Allowed Hec summer gain at DC for loop gain < 1 (no DC latch-up).

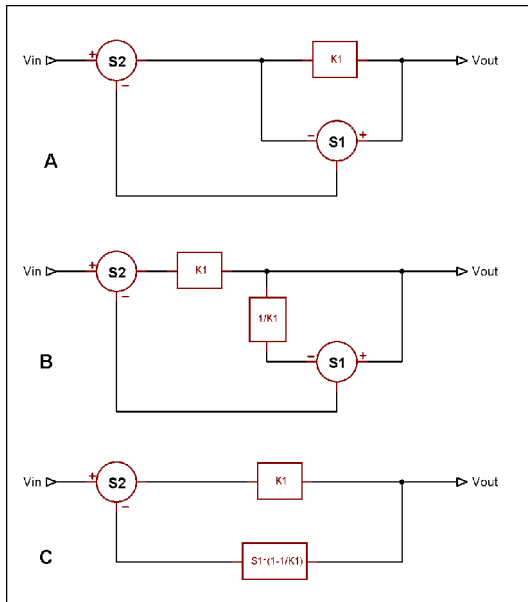
The writer states that the summer gain(s) S1, S2 will never be exactly 1, and that, if either one (or their product) exceeds 1, the loop gain exceeds +1 and DC latch-up will result.

It appears that the summer gain $S1 \cdot S2$ can be as large as the reciprocal of $1 - K1$ before the loop gain gets to '1'.

As an example, if $K1 = 0.8$ (a relatively low gain ef), the summer gain can be $S1 \cdot S2 = 5$ before latch-up occurs.

In the limiting case where $K1$ would be 1, $S1 \cdot S2$ could even become infinite.

If we now calculate the loop gain for DC, we get, after some manipulation, $G_{loop} = S1 \cdot S2 \cdot (1 - K1)$.

To avoid DC latch-up we need to ensure that G_{loop} remains less than 1, that $S1 \cdot S2 \cdot (1 - K1) < 1$, or, $S1 \cdot S2 < 1 / (1 - K1)$ where $K1 \leq 1$.
